## ADDENDUM NO. 2

**TO: PLANS AND SPECIFICATIONS FOR STATE OF MISSOURI**

**Helen M. Davis State School  
Repairs to Building Exterior & Replace Windows  
St. Joseph, Missouri  
PROJECT NO. E2412-01**

**GROUND FLOOR AND PARTIAL SITE PLAN**  
1/8" = 1'-0"

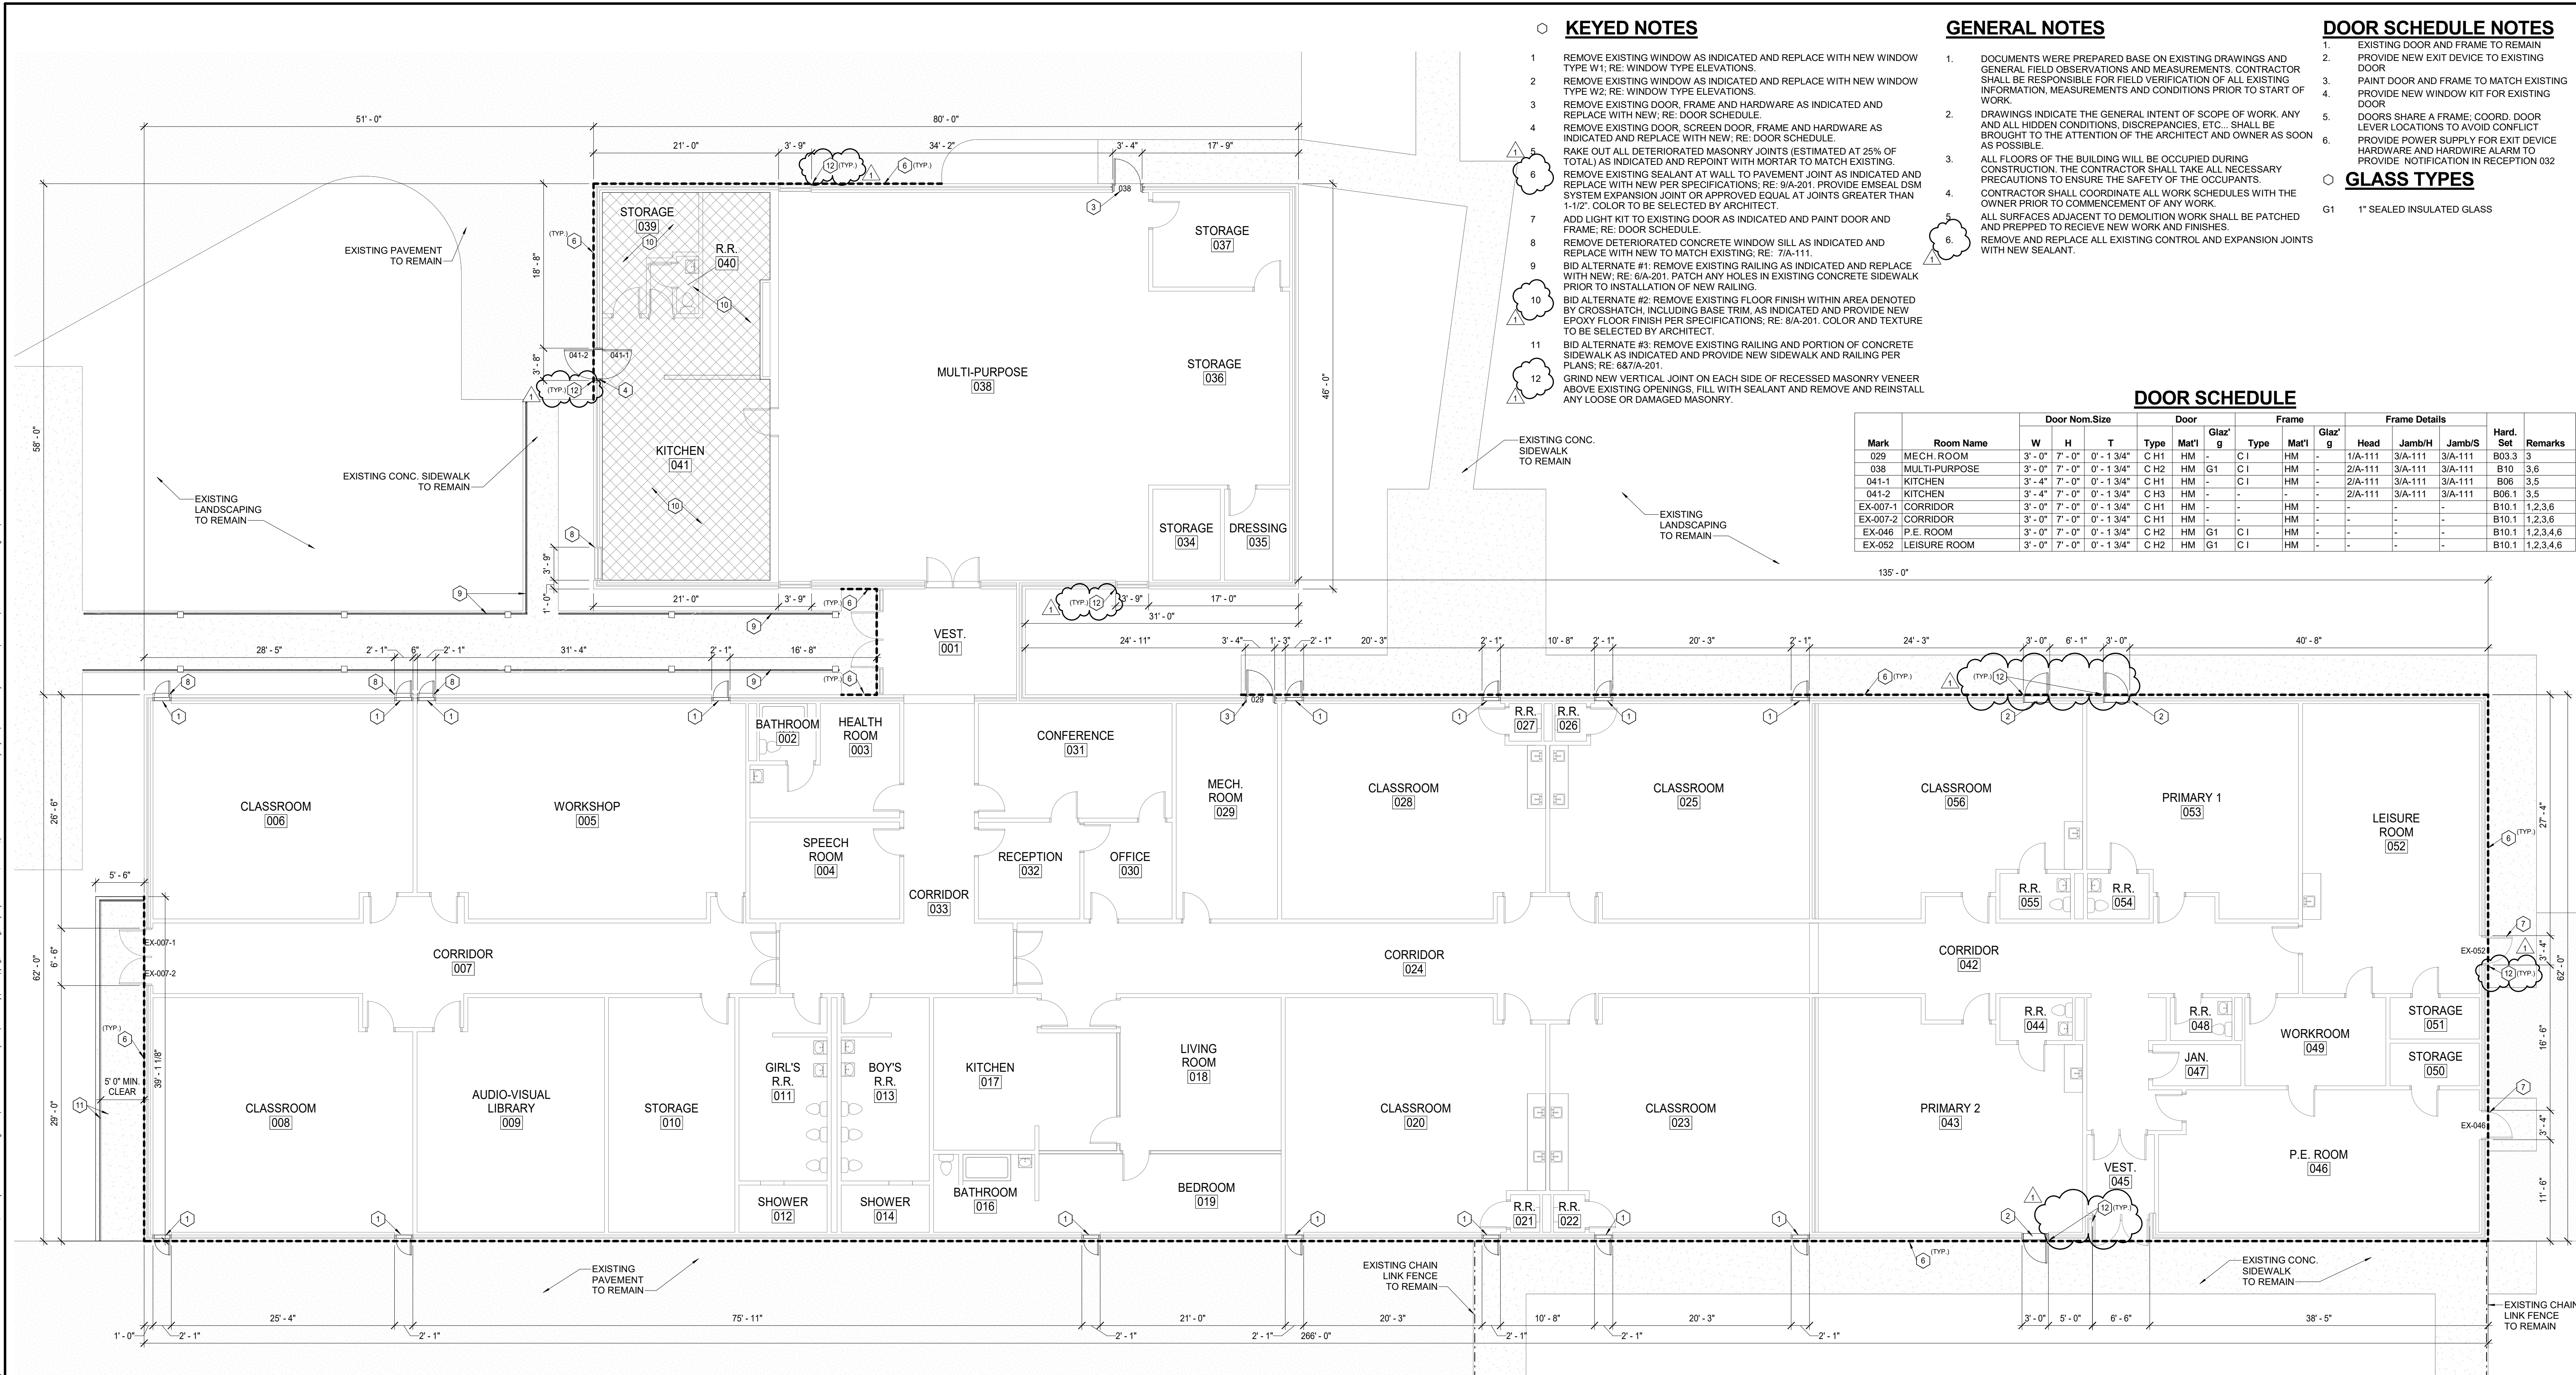
1. A-111 - Revised Keynote 6 to include alternate expansion joint material for joints larger than 1-1/2".
2. A-111 - Revised Keynote 10 to exclude reference to trowel application method. Floor finish to be applied using broadcast method per specifications.
3. A-111 - Added Keynote 12 to add new ground vertical joints at brick and cmu transitions over the existing window and door openings.
4. A-111 - Added General Note 6 to include removal and replacement of the existing control and expansion joints in the masonry veneer.

- 5 RAKE OUT ALL DETERIORATED MASONRY JOINTS (ESTIMATED AT 25% OF TOTAL) AS INDICATED AND REPOINT WITH MORTAR TO MATCH EXISTING.
- 6 REMOVE EXISTING SEALANT AT WALL TO PAVEMENT, JOINT AS INDICATED AND REPLACE WITH NEW PER SPECIFICATIONS. RE: 8/A-201. PROVIDE EMSEAL DSM SYSTEM EXPANSION JOINT OR APPROVED EQUAL AT JOINTS GREATER THAN 1'-0". COLOR TO BE SELECTED BY ARCHITECT.

- 10 BID ALTERNATE #2: REMOVE EXISTING FLOOR FINISH WITHIN AREA DENOTED BY CROSSHATCH, INCLUDING BASE TRIM, AS INDICATED AND PROVIDE NEW EPOXY FLOOR FINISH PER SPECIFICATIONS. RE: 8/A-201. COLOR AND TEXTURE TO BE SELECTED BY ARCHITECT.
